## Wilsonville City Hall Development Review Board Panel B

Monday, August 28, 2017 - 6:30 P.M.

**A. Resolution No. 339**

**Marion's Carpet Warehouse: Bob Schatz, Allusa Architecture - Applicant for Bergaso Properties - Owner.** The applicant is requesting approval of a Stage I Preliminary Plan, Stage II Final Plan, Setback Waiver, Site Design Review, Class 3 Sign Permit and Type C Tree Plan for construction of a tilt-up slab warehouse with retail space on SW Boones Ferry Road. The subject property is located on Tax Lot 1300 of Section 14A, T3S, R1W, Clackamas County, Oregon. Staff: Kimberly Rybold

PROJECT NO. 17-042	SHEET
DATE 6/28/17	C.11
SCALE 1" = 20'

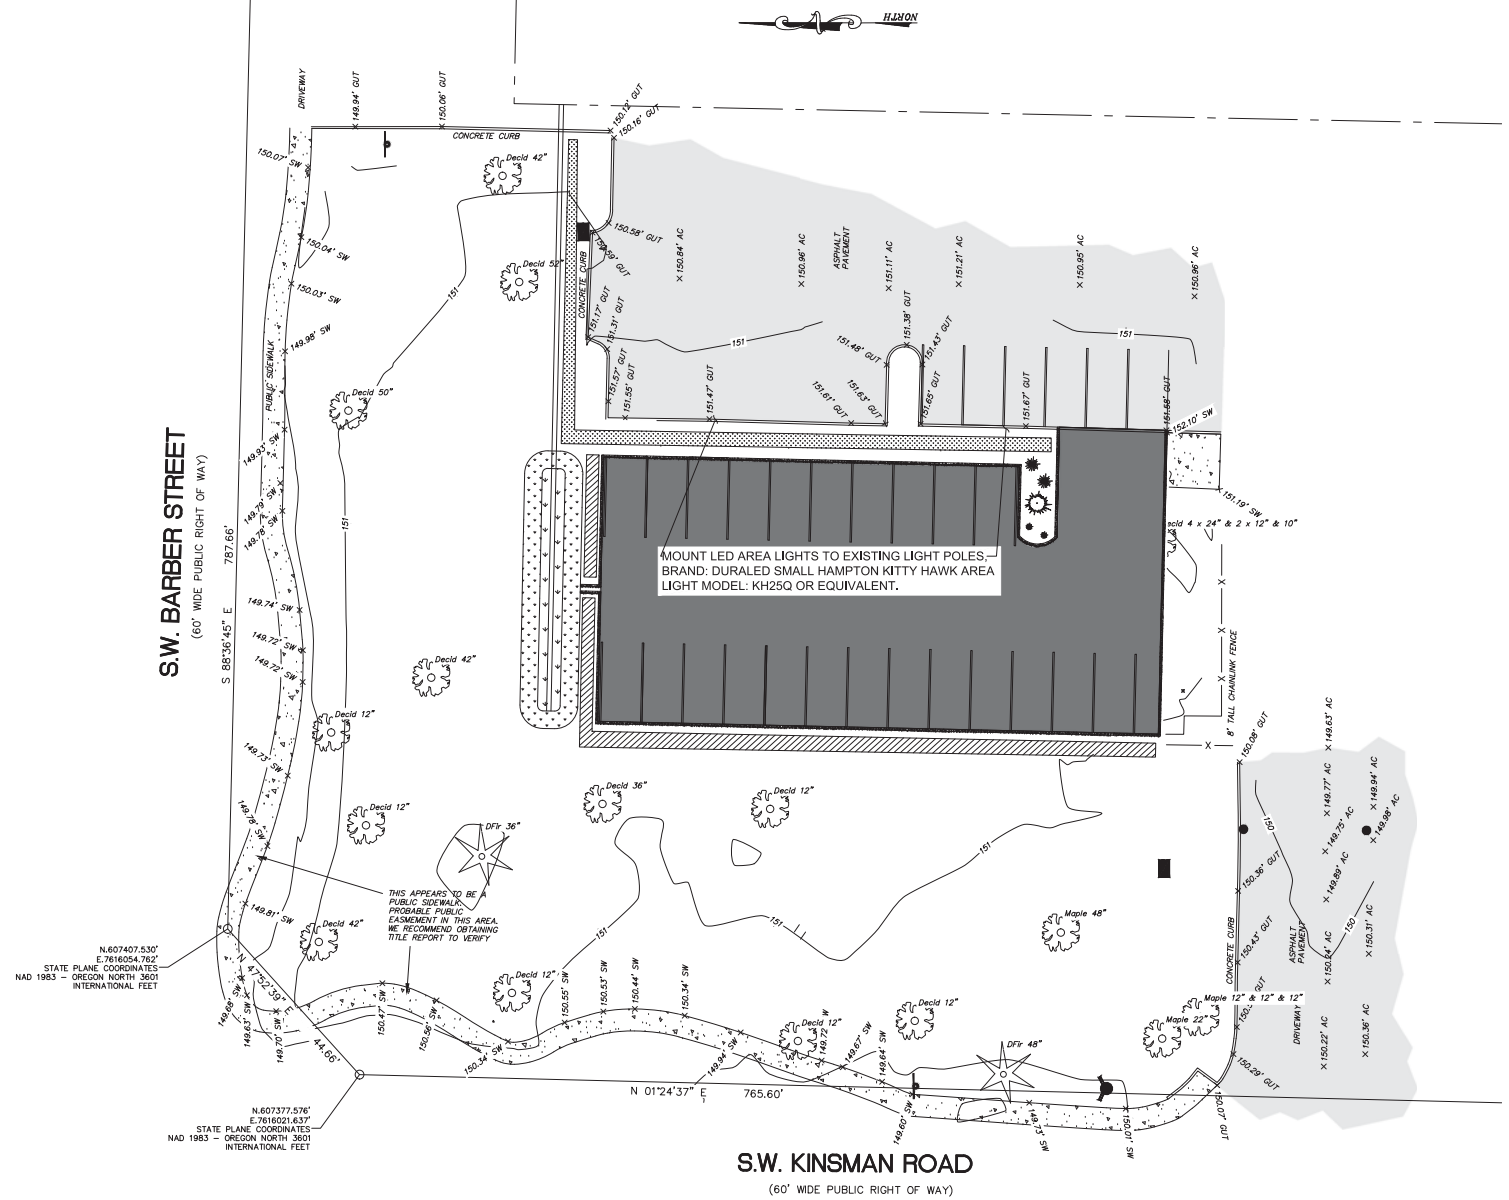
**Response:** As indicated on sheet C.11 of Exhibit B2 an English laurel hedge, matching an existing one, will be installed as the required screening.

**Response:** An appropriate landscape design has been provided. See sheet C.11 of Exhibit B2.

**Response:** As shown on sheet C.11 of Exhibit B2 required materials for each landscaping standard is provided as follows. In all area appropriate groundcover is provided for areas without not otherwise occupied by shrubs and trees:

PROJECT NO. 17-042	SHEET
DATE 6/28/17	C.7
SCALE 1" = 20'

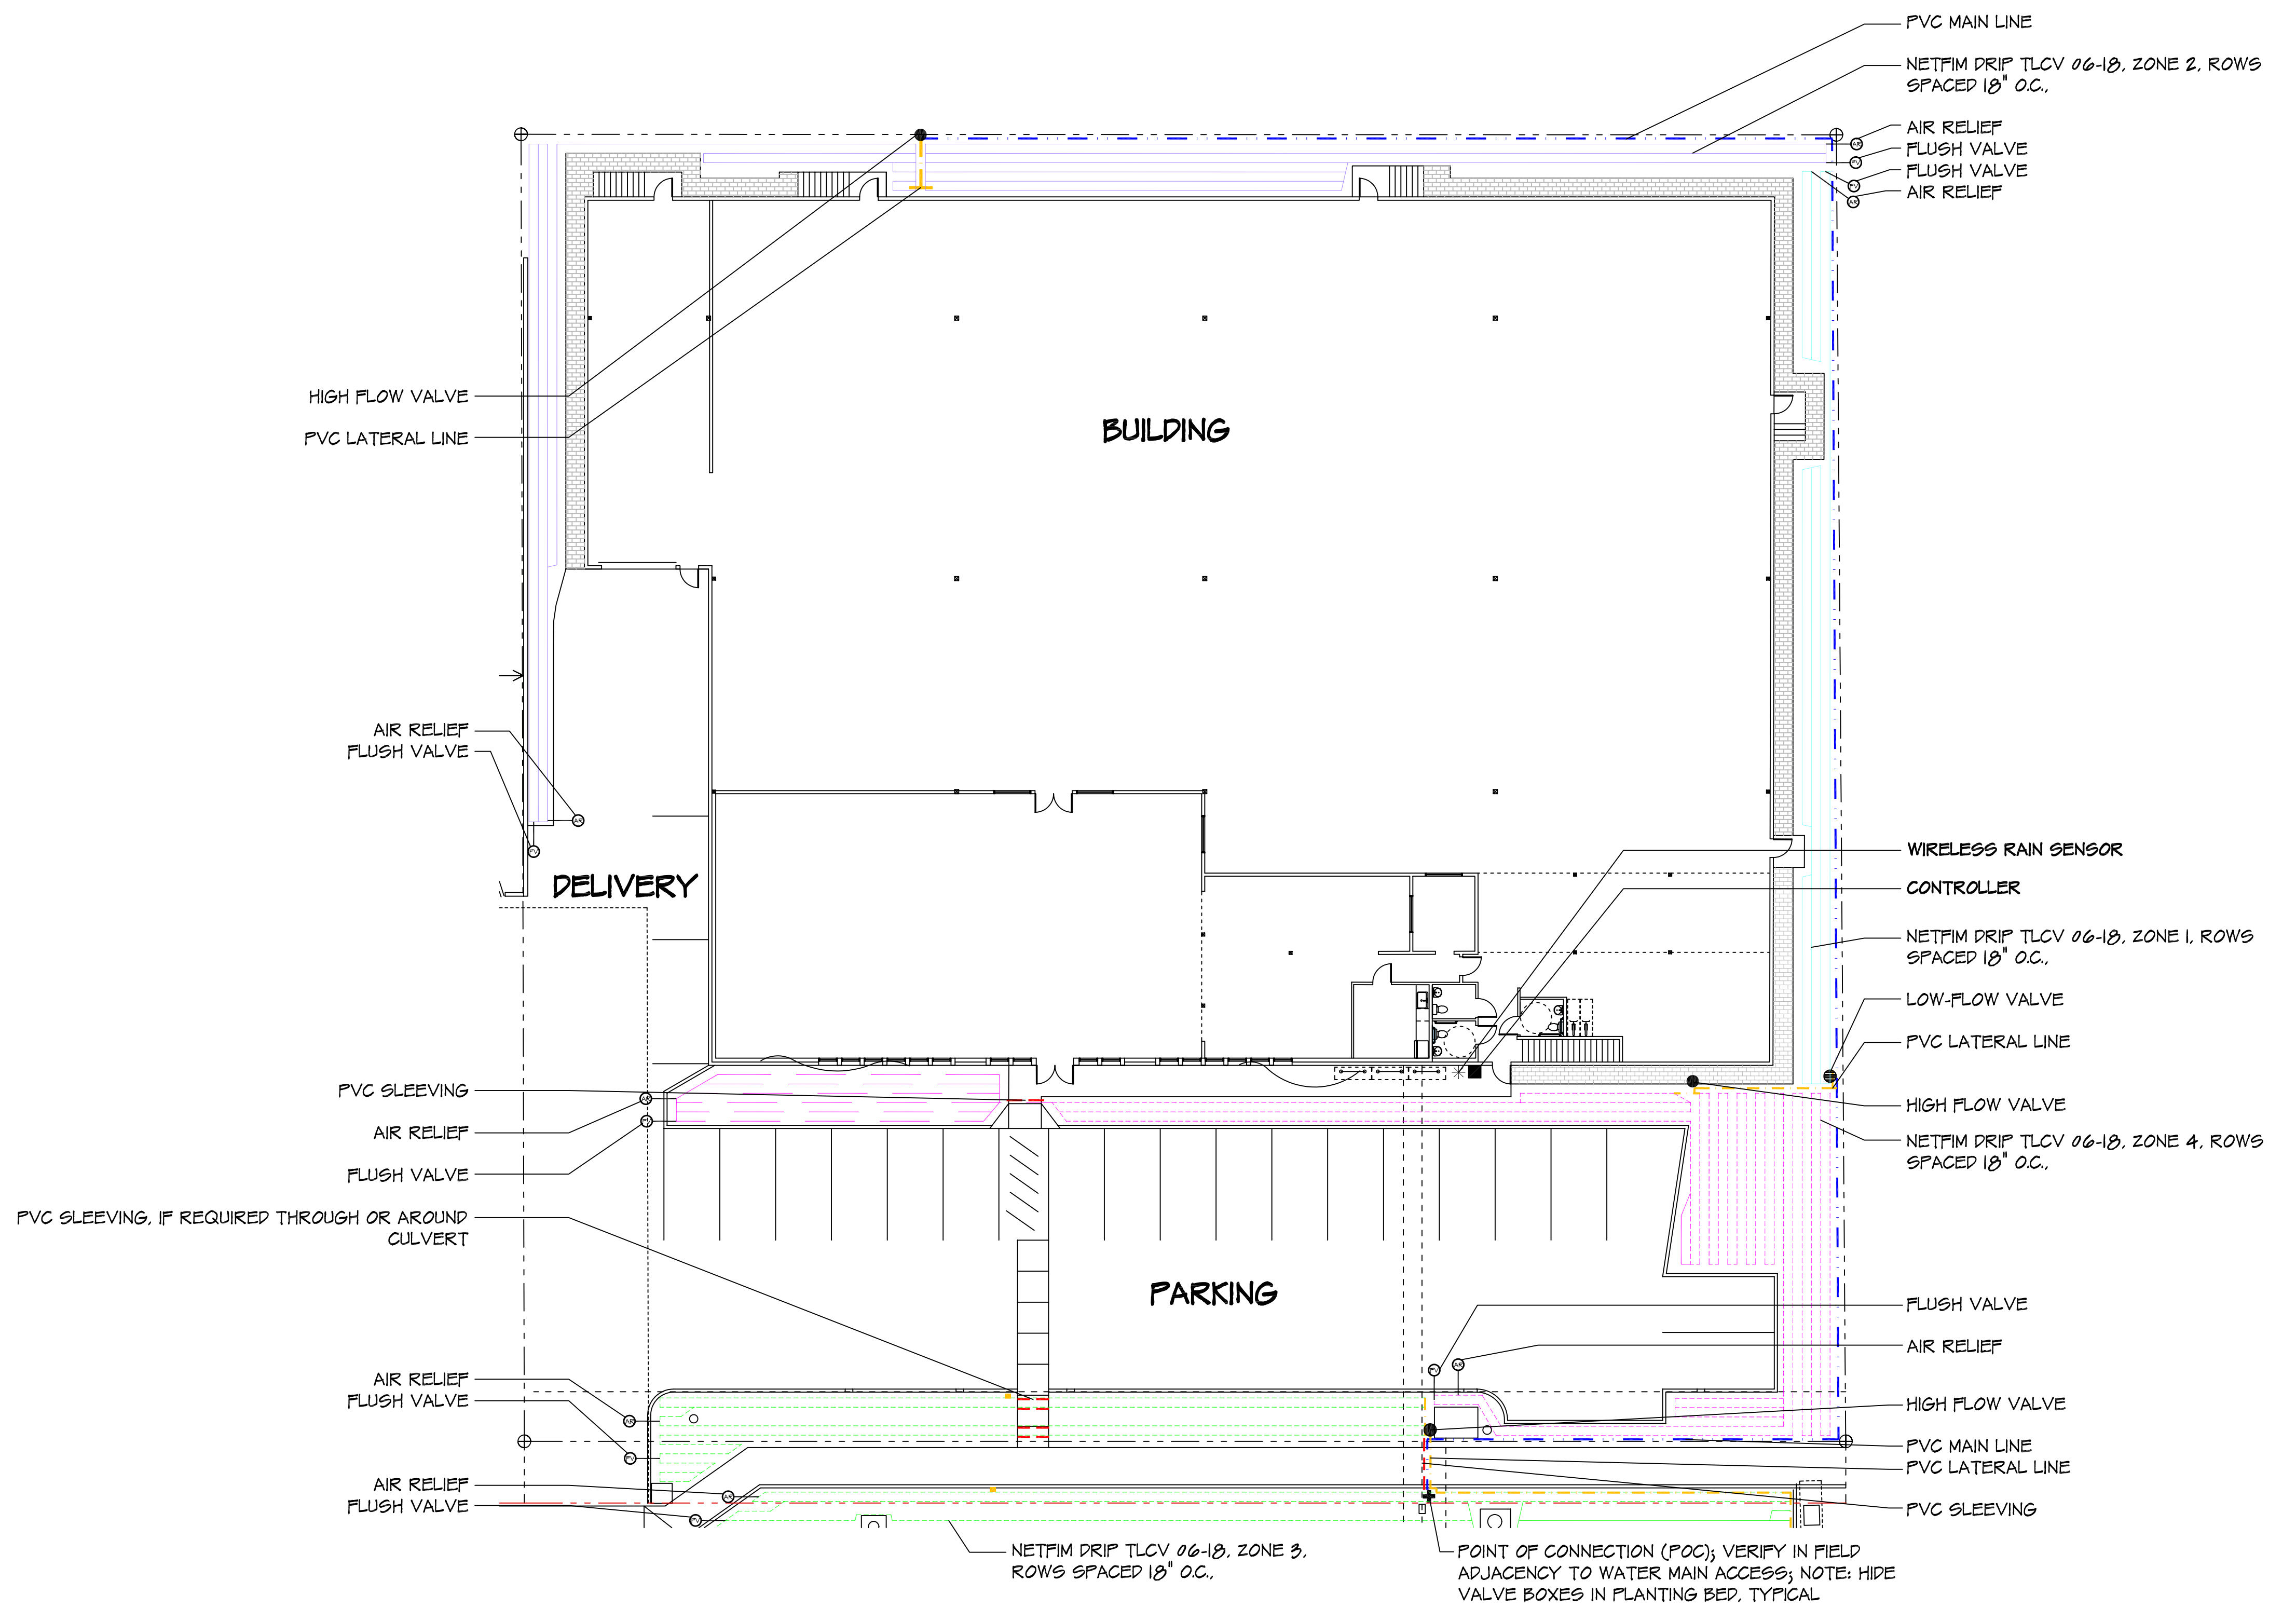
**Response:** This subsection indicates that shrubs should equal to or better than 2-gallon containers. Some of the proposed shrubs on the applicant’s planting plan (sheet L1, Exhibit B2) are proposed to be 1-gallon containers. Condition of Approval PDD 5 requires that the detailed requirements of this subsection are met.

<b>PDF 4.</b>	The Applicant/Owner shall install the required 44 mitigation trees, as shown in the Applicant's sheet L1, per Section 4.620 WC.
<b>PDF 5.</b>	The permit grantee or the grantee's successors-in-interest shall cause the replacement trees to be staked, fertilized and mulched, and shall guarantee the trees for two (2) years after the planting date. A "guaranteed" tree that dies or becomes diseased during the two (2) years after planting shall be replaced.
<b>PDF 6.</b>	Prior to site grading or other site work that could damage trees, the Applicant/Owner shall install six-foot-tall chain-link fencing around the drip line of preserved trees, including those trees identified in Condition of Approval PDF 3. Removal of the fencing around the trees identified in PDF 3 shall only occur if it is determined the trees are not feasible to retain. The fencing shall comply with Wilsonville Public Works Standards Detail Drawing RD-1230. See Finding F14.
